PLANS AND DOCUMENTS
referred to in the
APPROVAL
Dated: 05/04/2024

Project
Subdivision
168 Junction Road, Morningside,
QLD 4170

Drawing Title
Site Plan

PROPOSED RESIDENTIAL SUBDIVISION
LOT 62 ON RP12846
168 JUNCTION ROAD, MORNINGSIDES
PRELIMINARY SERVICES PLAN
DAN POLZI

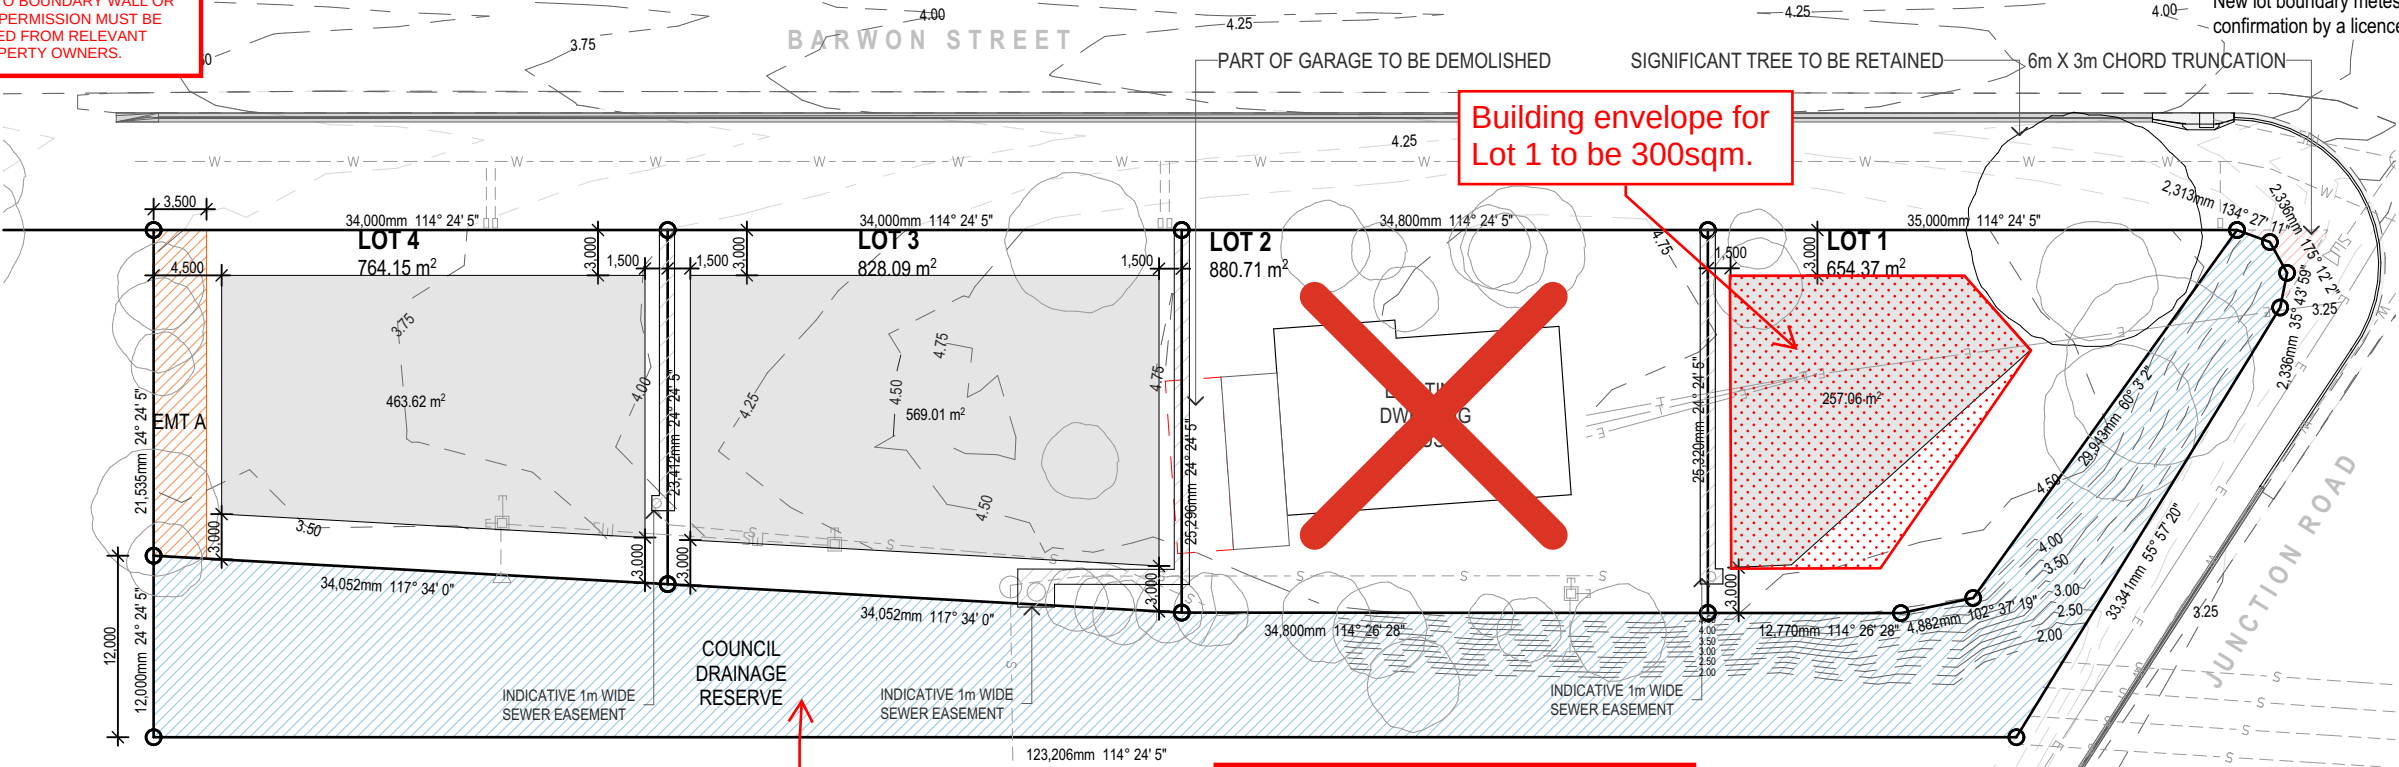
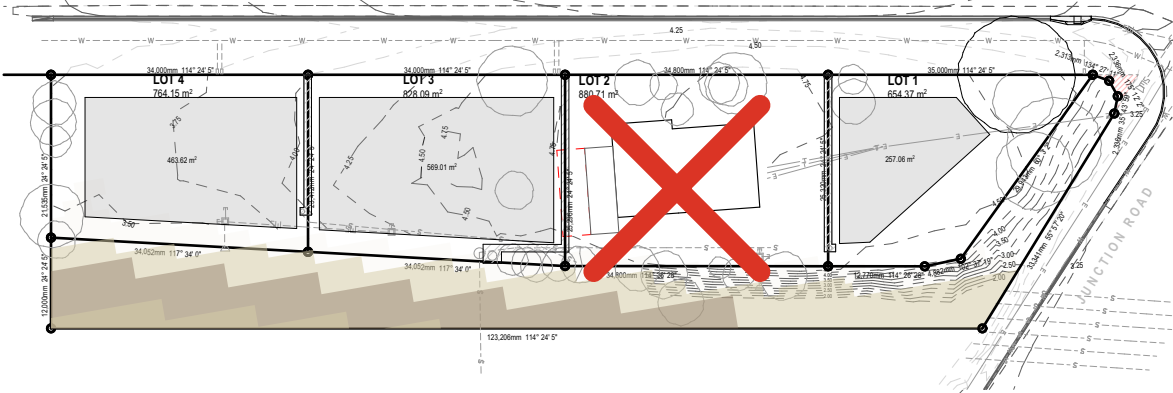
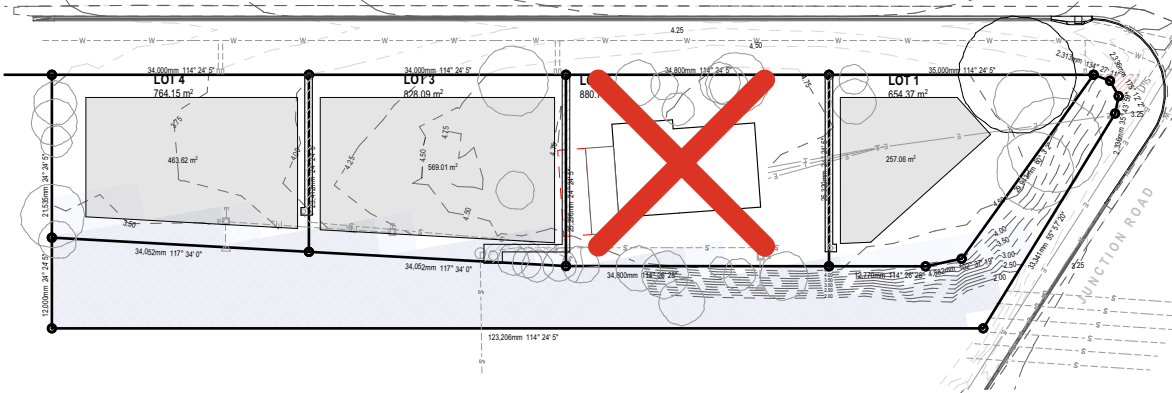
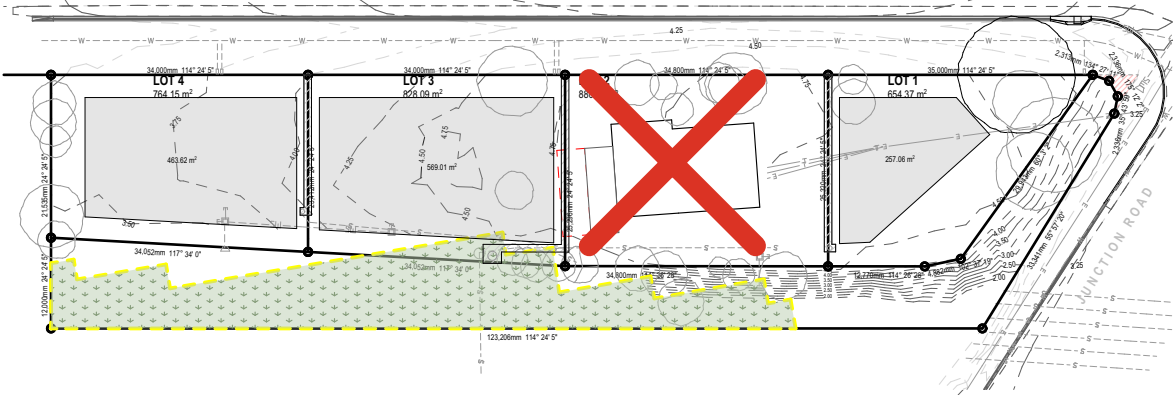
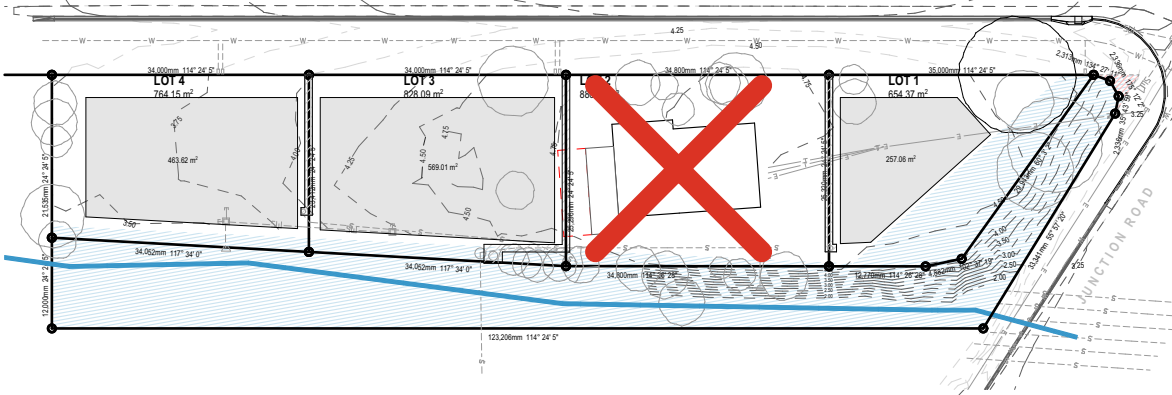
AMENDED IN RED
27/03/2024

Land for Stormwater Network - Stormwater (Non-Trunk) as per conditions.

PRELIMINARY SERVICES PLAN

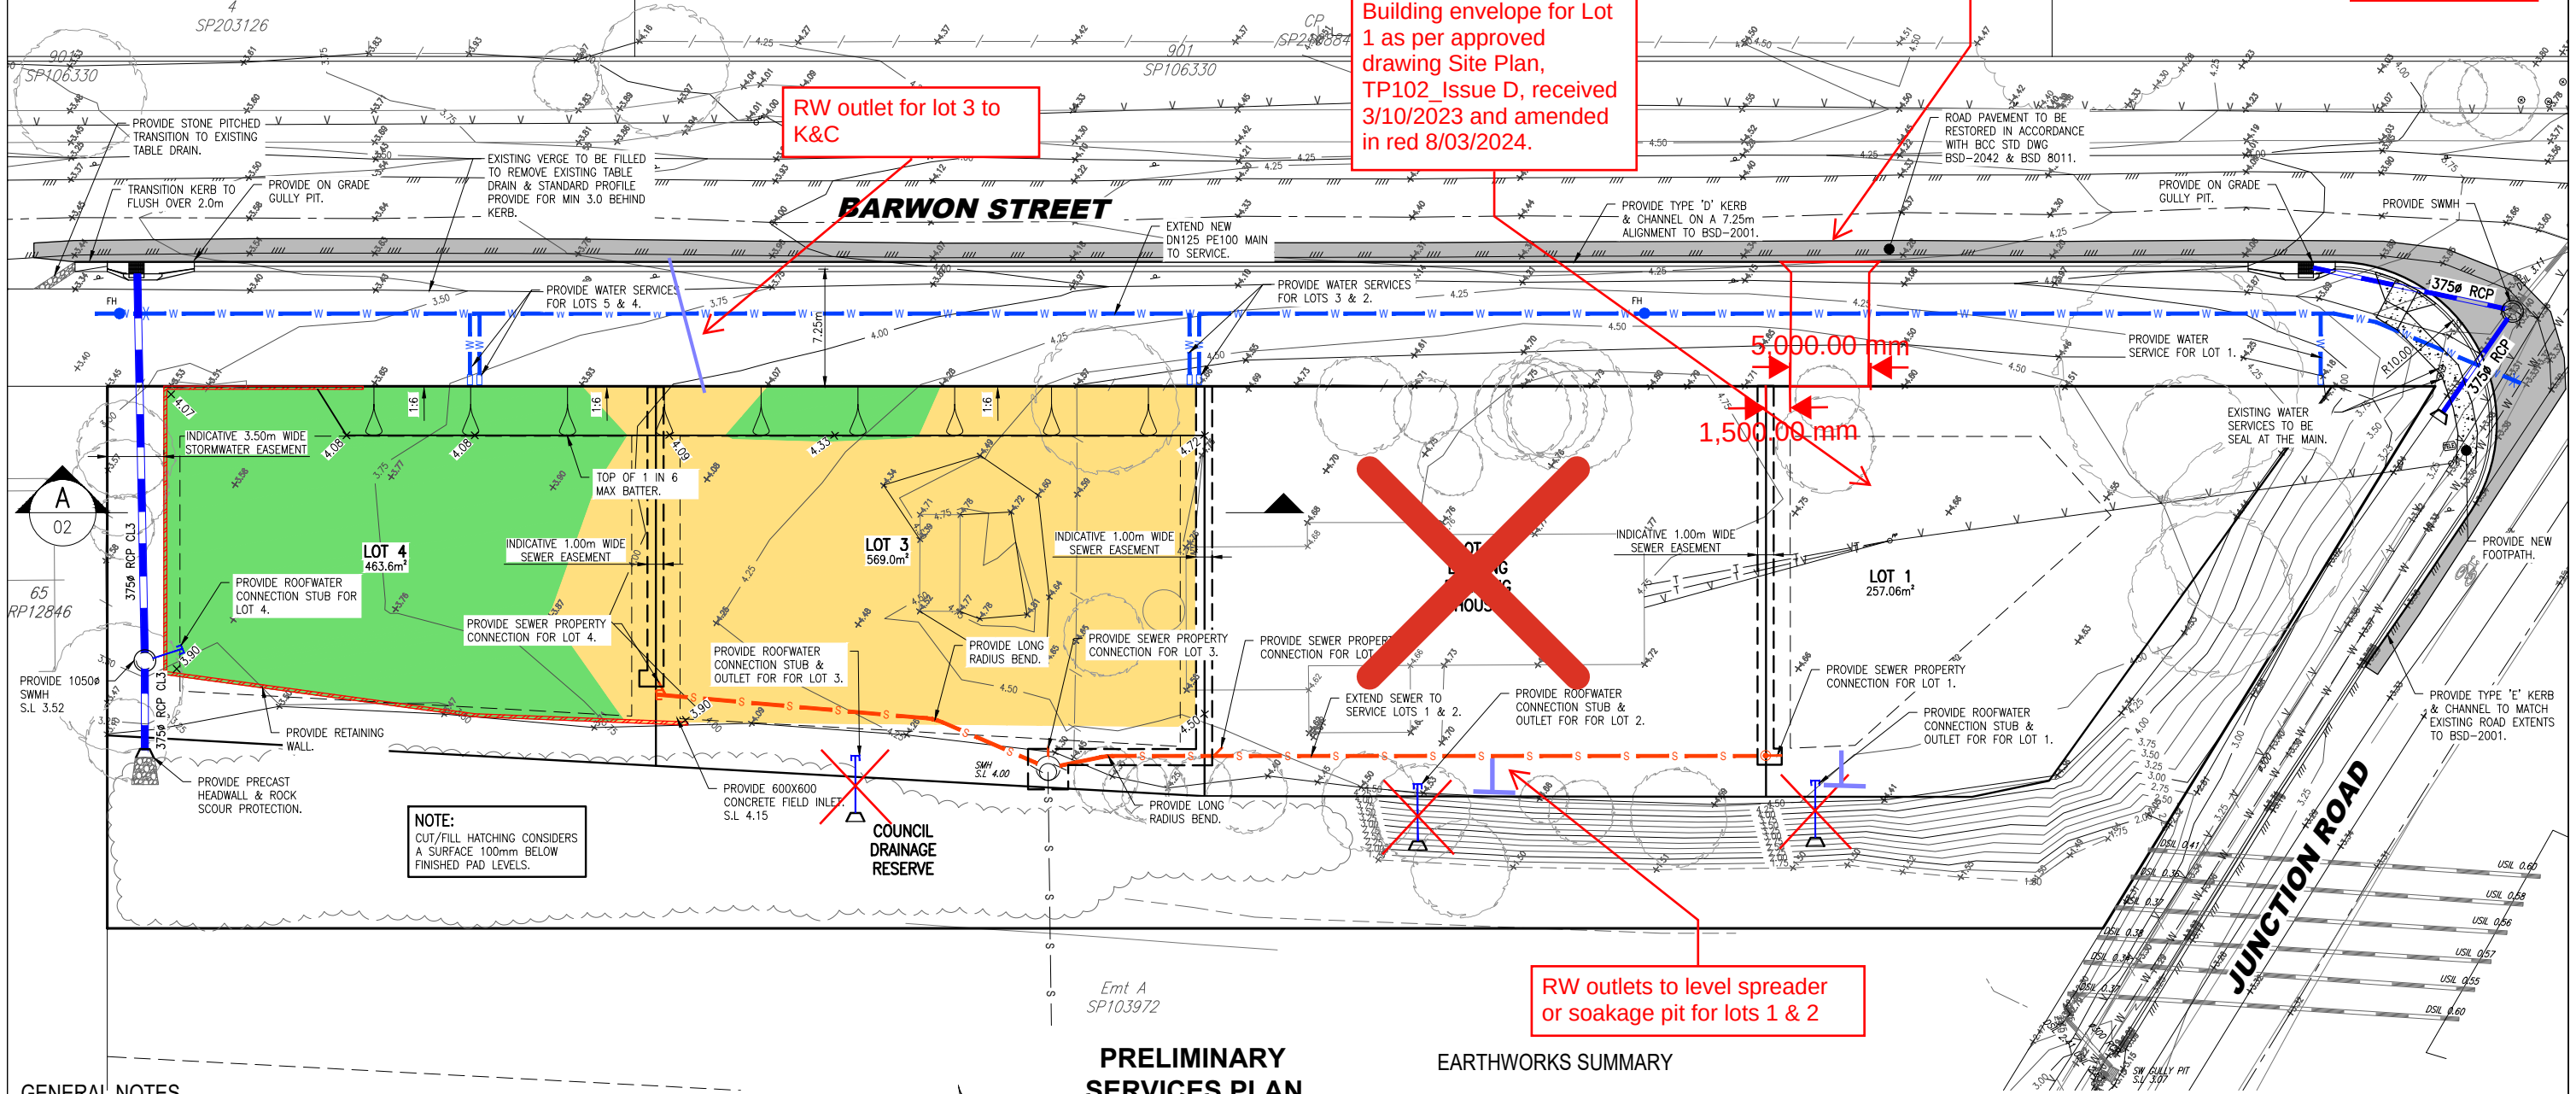
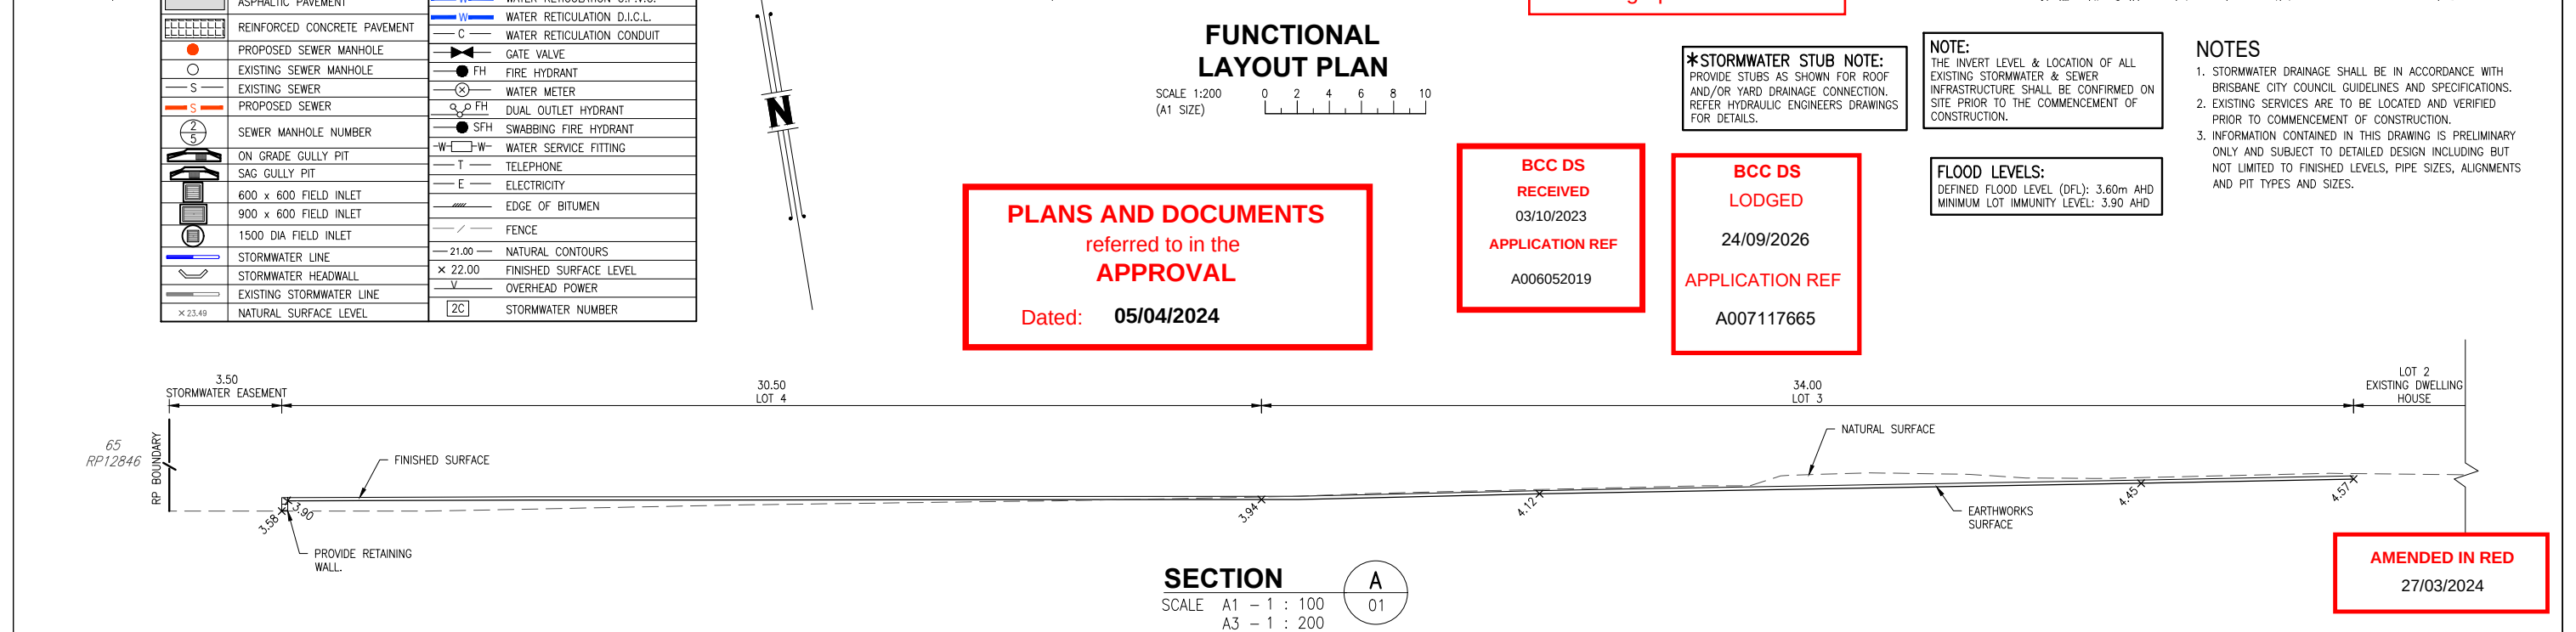
AMENDED IN RED
27/03/2024
